I PROJECT:	Wynot Public School Addition & Renovation	PROJECT NO.	L14208
FROM:	BVH Architects	DATE:	17 March 2016
TO:	All Bidders	ADDENDUM NO.	1

Wynot Public School Addition and Renovation
R.O. Youker, Inc. Project #16005
Addendum 1 Items
3/17/2016

addendum no. 1

N16 TYP CASEWORK - TALL WARDROBE CABINET
 1" = 1'-0"

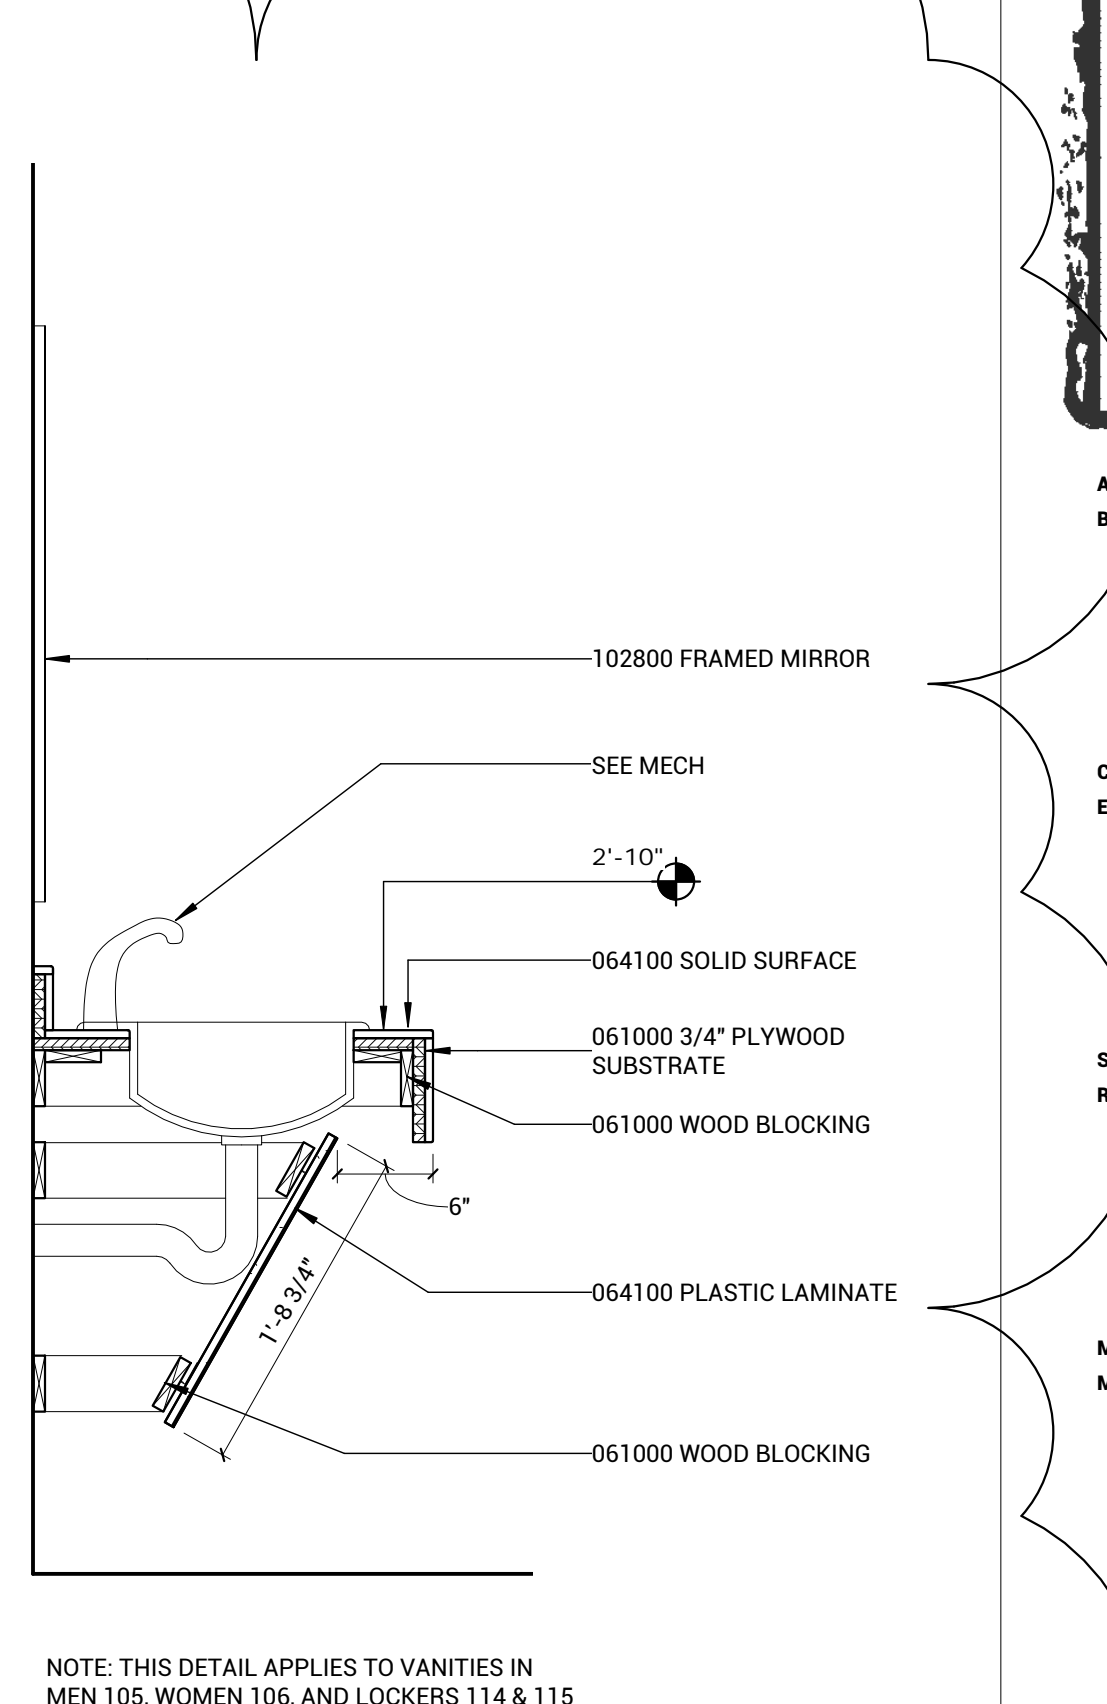
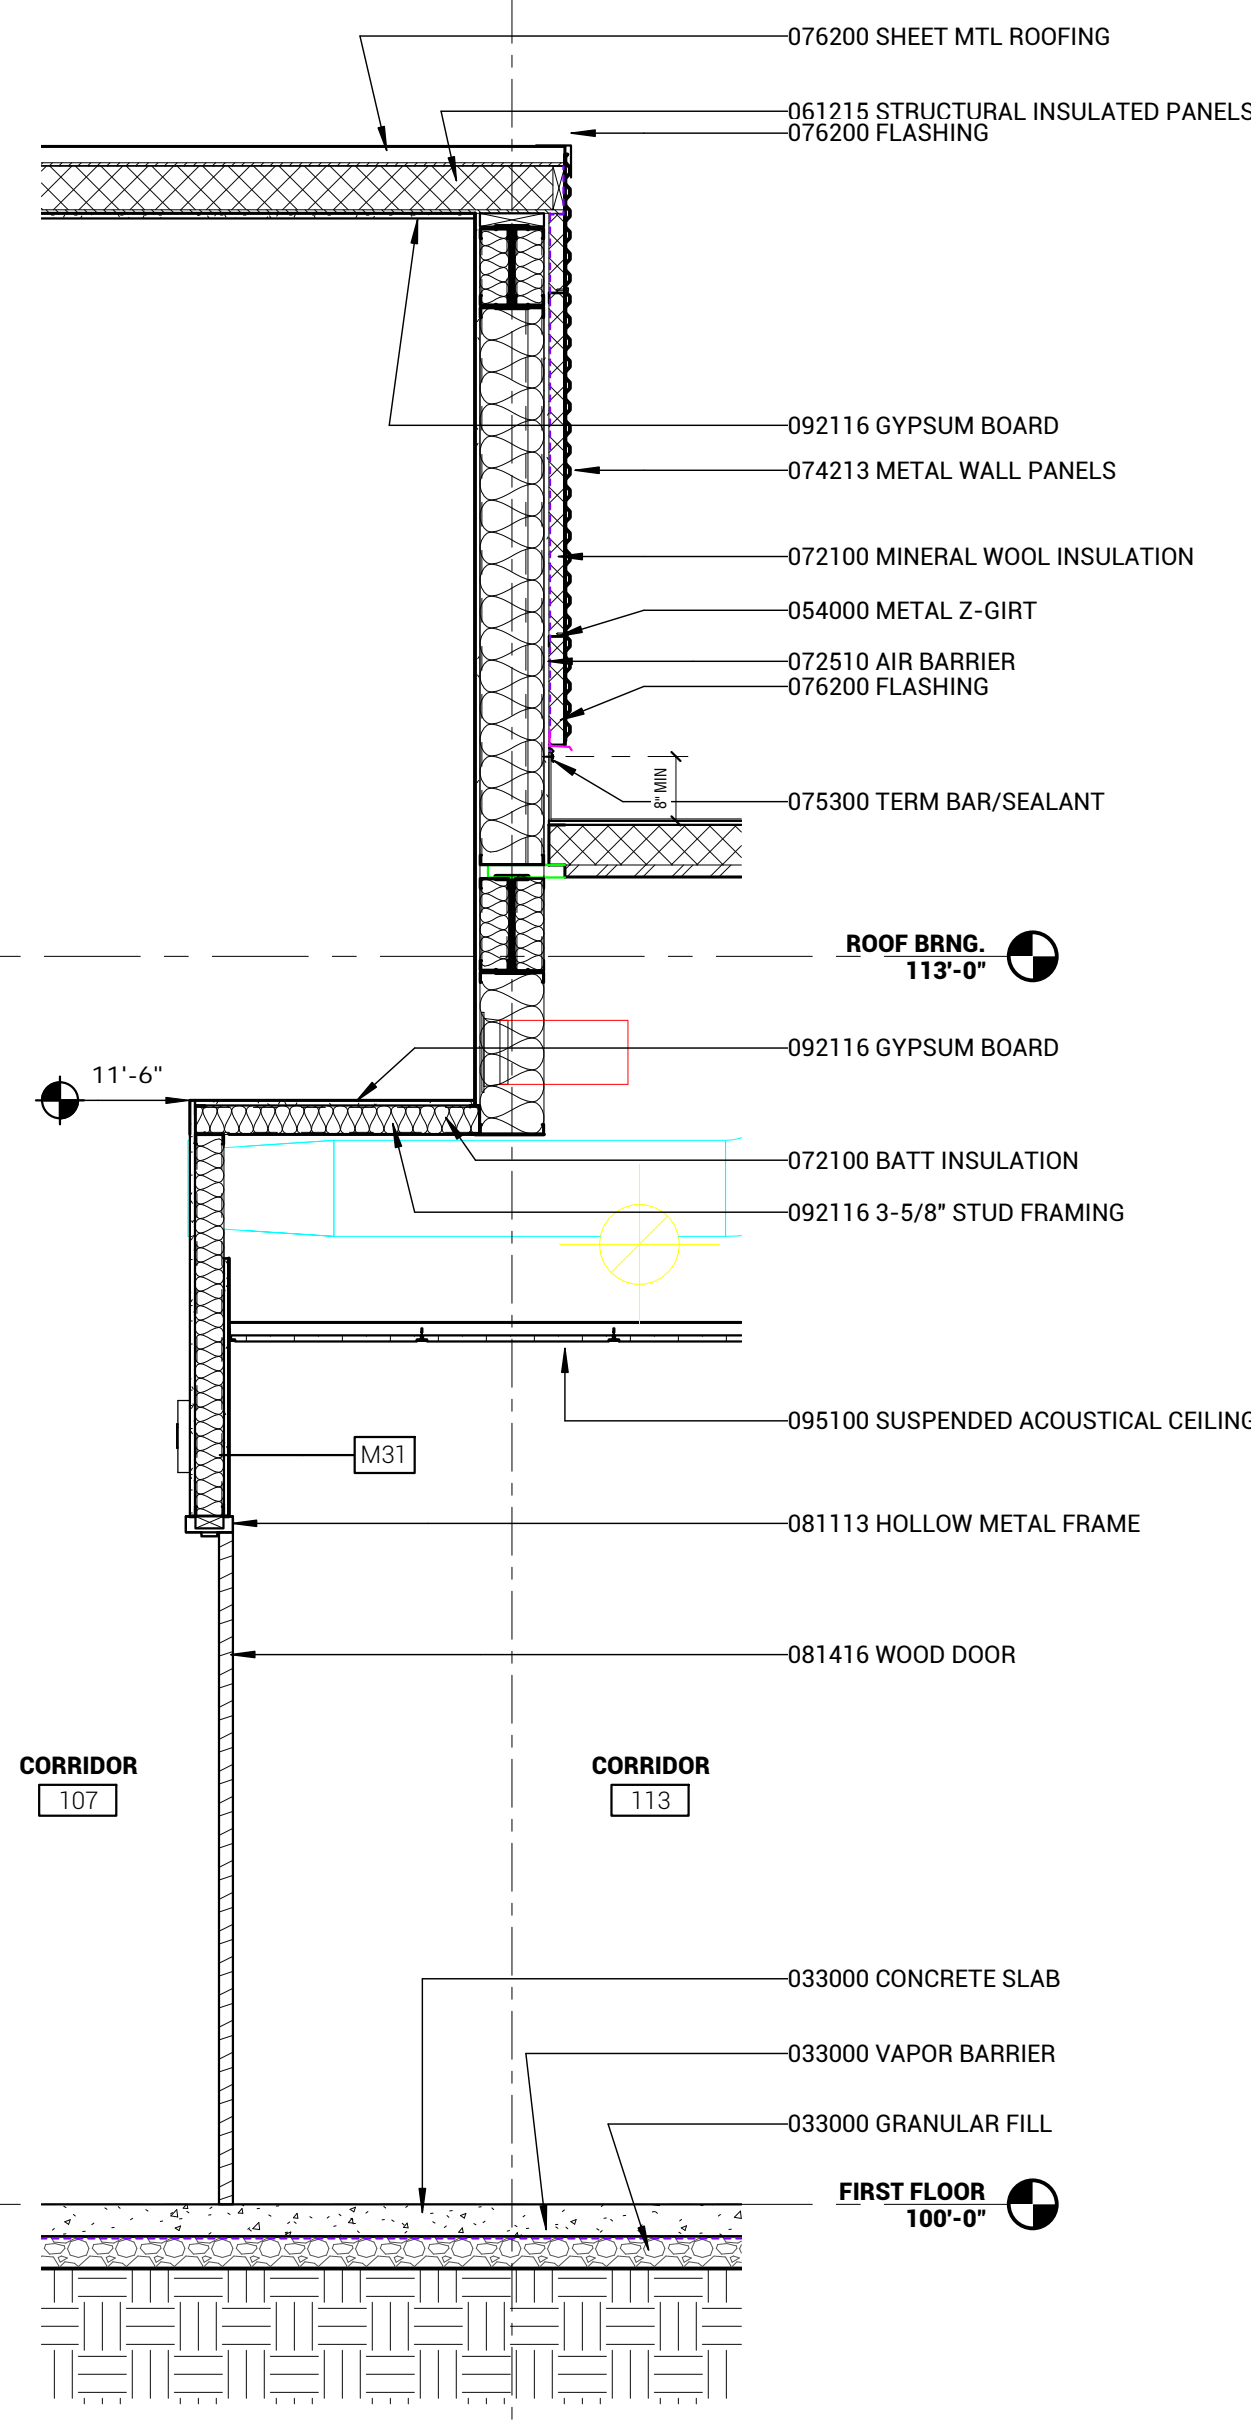
- b. Detail B13 (refer to attached Drawing 1)
 1. Window head and parapet revisions.
5. Sheet A5.3 Wall Sections (refer to re-issued sheet A5.3)
 - a. Typical casework sections added.
